650 NORTH SAN PEDRO ROAD AMENDED FINAL EIR

STATE CLEARINGHOUSE NUMBER: 2004062004

County of Marin | October 22, 2010

FIGURE 6
SITE DISTANCE FROM LOT 12 DRIVEWAY

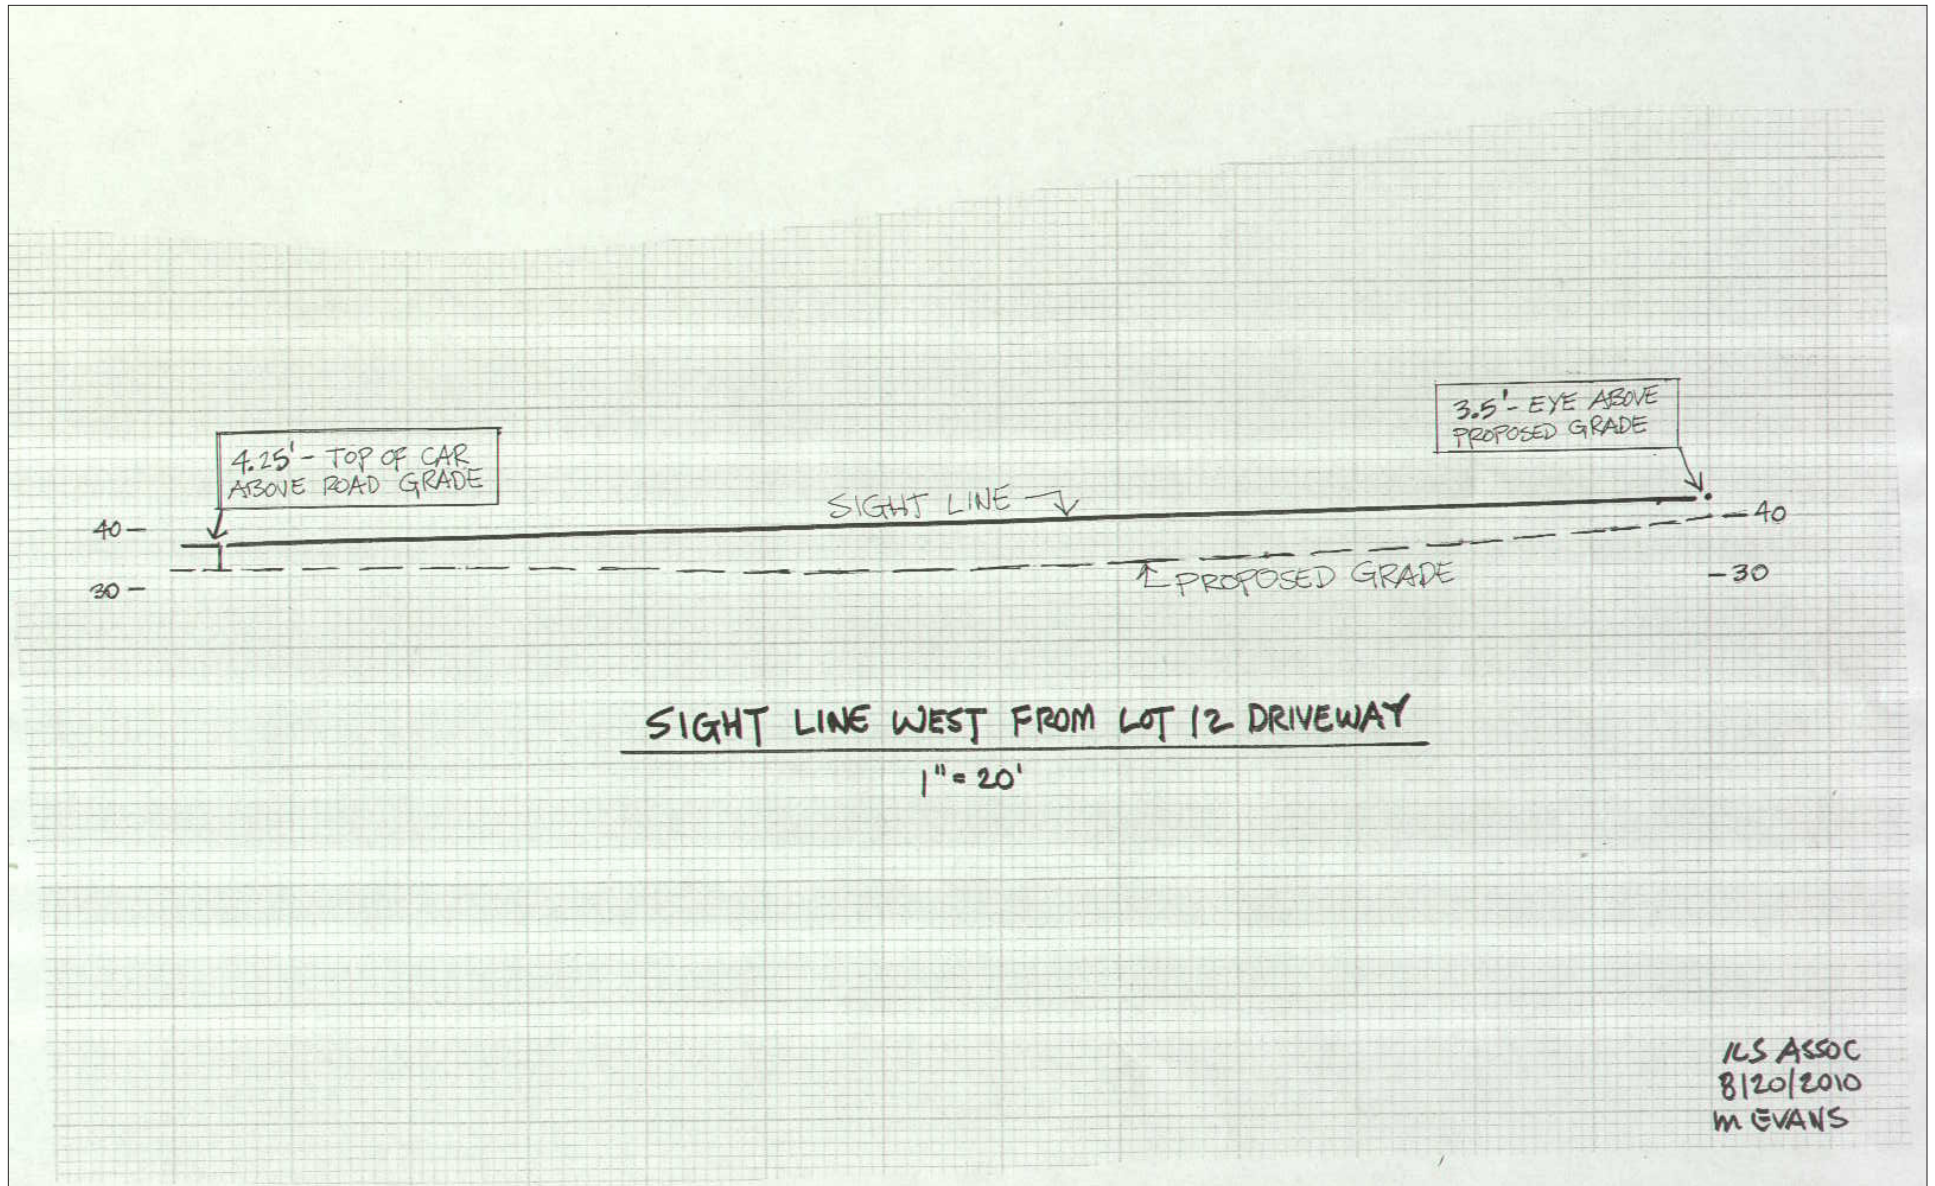
Figures 4 and 5 in Appendix L, show photos of markers demonstrating a direct line of sight 250 feet in each direction from the exit point of the driveway to Lot 12. Figure 6 shows the sight distance line from the Lot 12 driveway. Figures 7 and 8 show sight line profiles from Lot 12. Additional language,

FIGURE I
LAND USE COMPATIBILITY ANALYSIS MAP

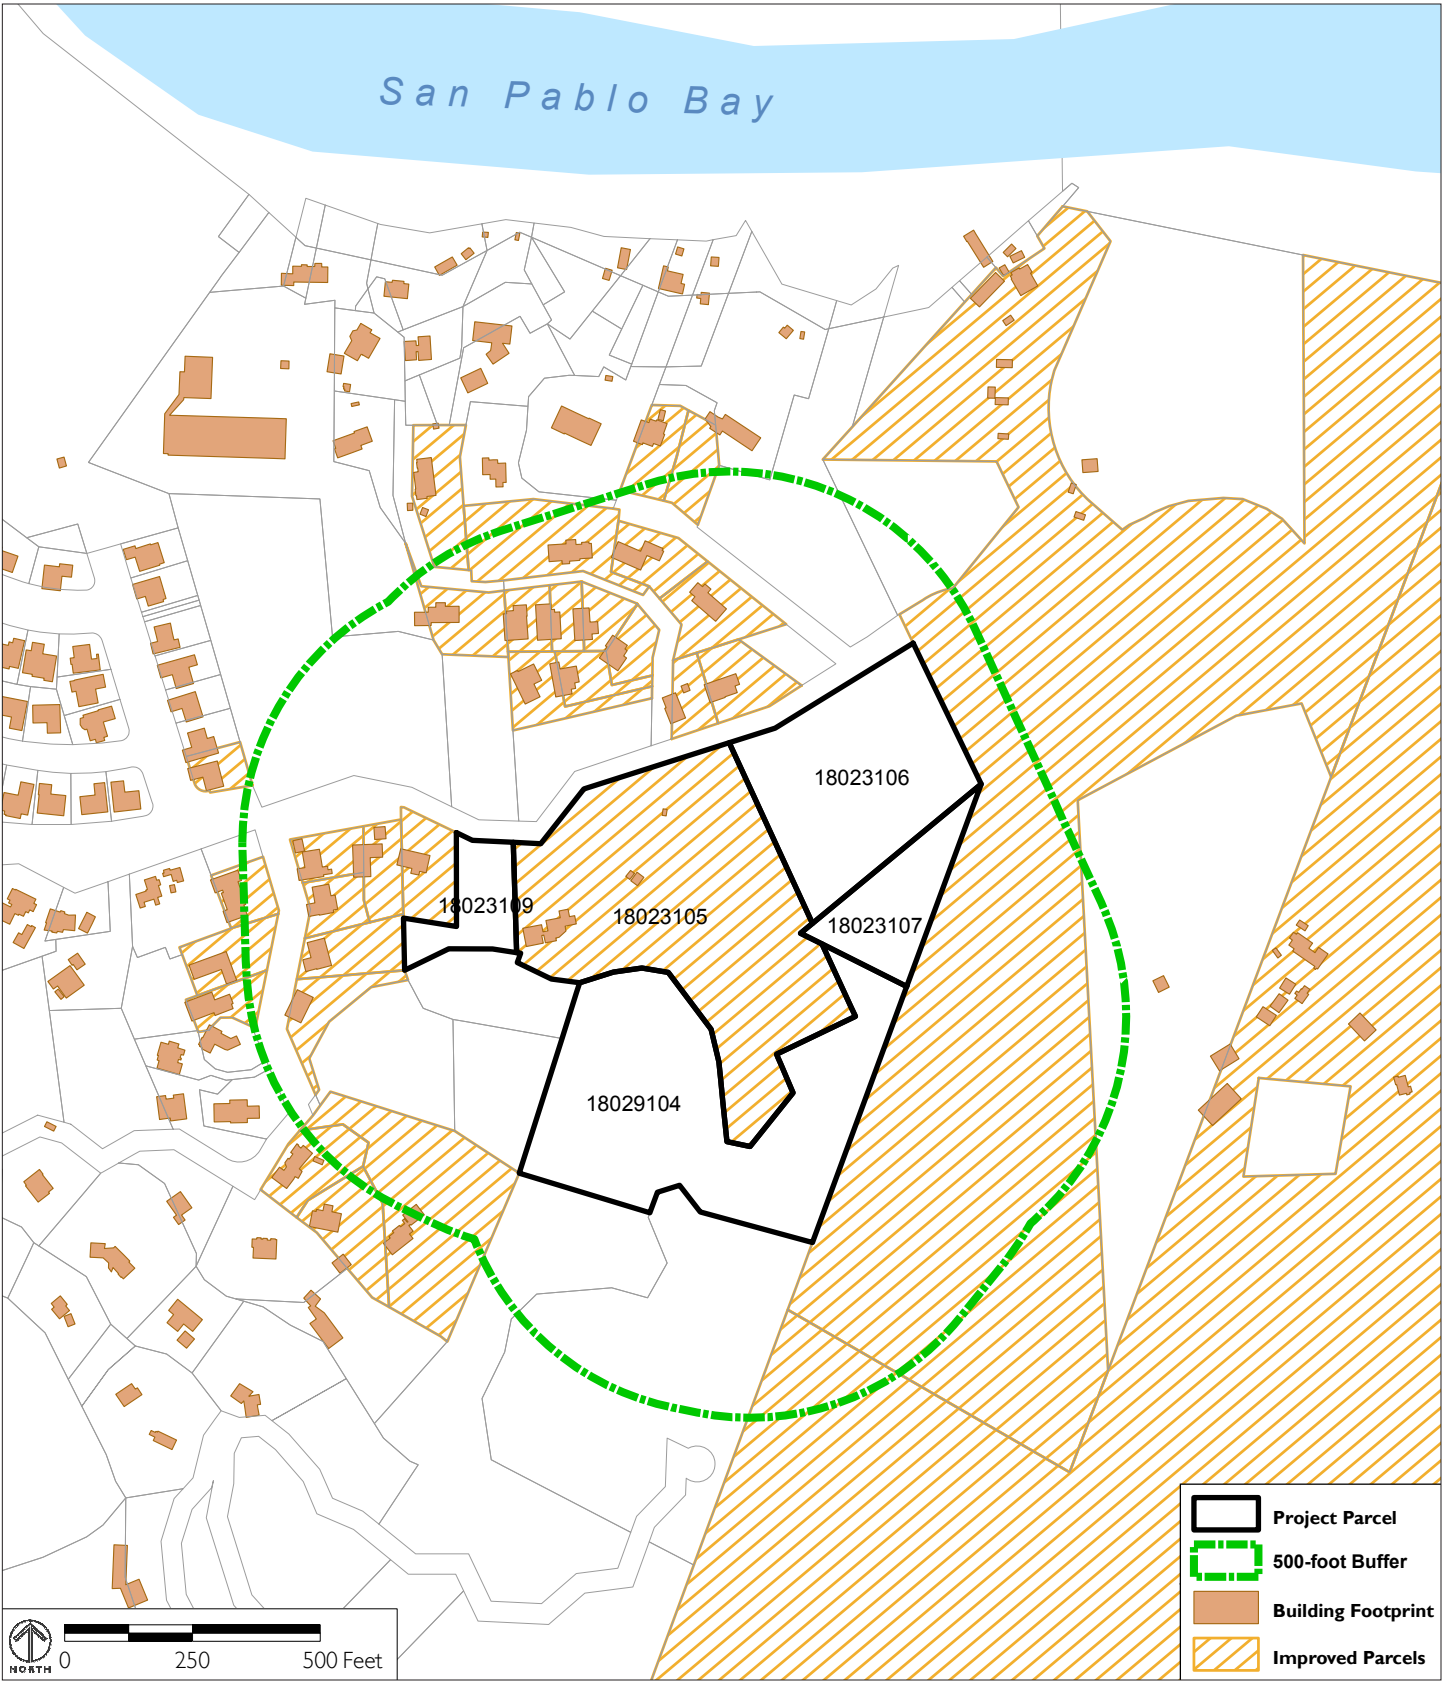
The GIS map used in this analysis is provided in Figure 1 of Appendix N to show the parcels compared to the project site.
